TECHNICAL SERVICE BULLETIN

Single Rear Wheel Only - Boom/Hum/Moan Noise From Rear While Driving At Highway Speeds

22-2444

Ford 2015-2023 Transit	Single Rear Wheel Only (Does Not Apply To Dual Rear Wheel Vehicles)
----------------------------------	---

Figure 1

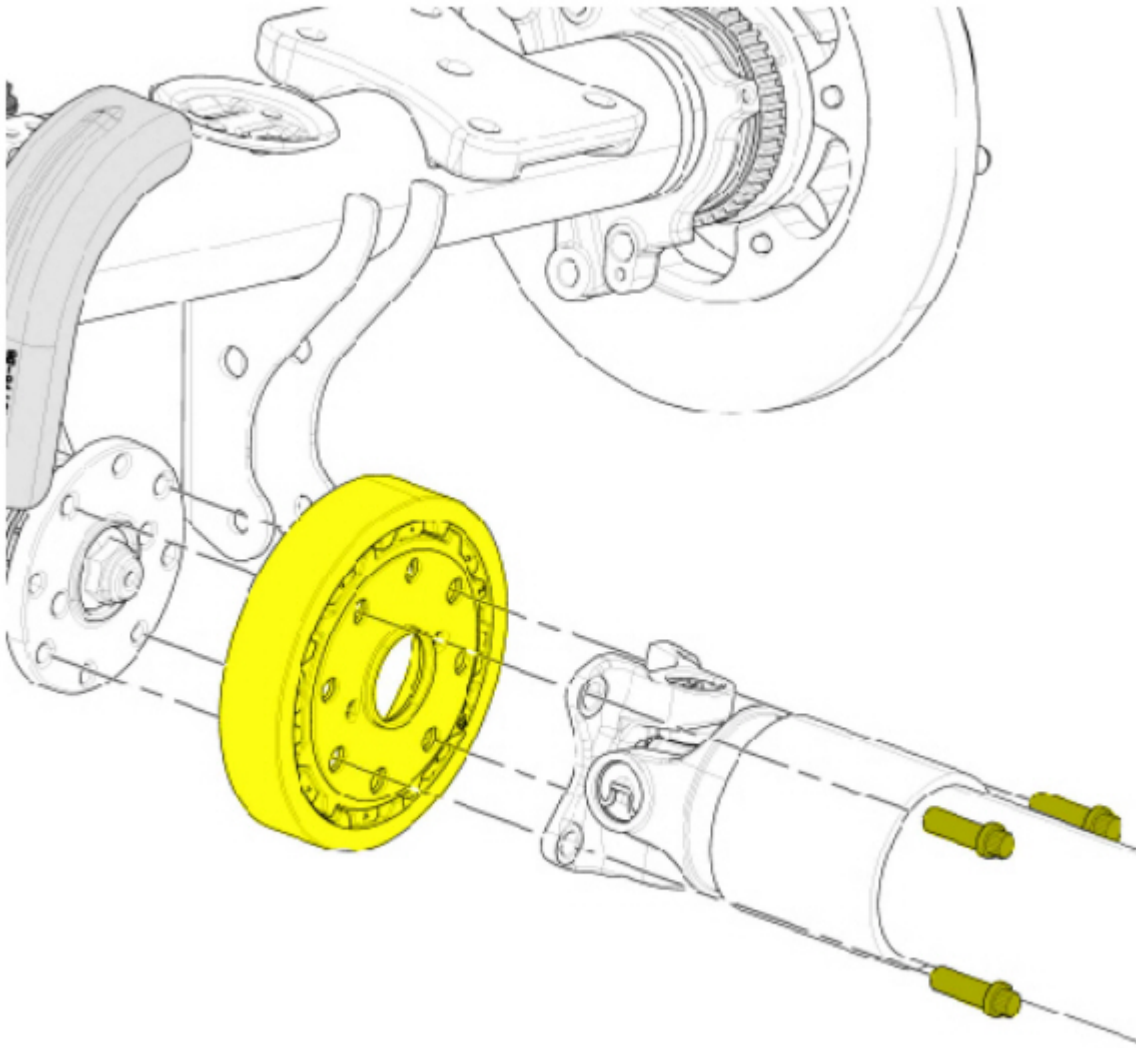
The noise may also be present to a lesser degree at roughly half of the noted speeds. This may be due to a 2nd order driveline frequency transmitted through the rear driveshaft, rear axle and into the body through the leaf springs. To correct the condition, follow the Service Procedure to install a driveshaft torsional damper.

6. Inspect the pinion flange to driveshaft mating surface for any debris or excessive rust and clean as necessary.
7. Install the driveshaft torsional damper on the axle pinion flange. (Figure 1)

8. Align the index mark on the driveshaft and rear drive pinion flange and reinstall the driveshaft. Make sure the driveshaft fits securely over the raised flange on the torsional damper.

(1). Apply Loctite 263 to each of the 4 cleaned bolts. (Loctite to be applied in the engagement area, first 7 threads) Install the driveshaft attaching bolts and tighten to 115 Nm (85 lb-ft). Refer to WSM, Section 205-01. (Figure 1)
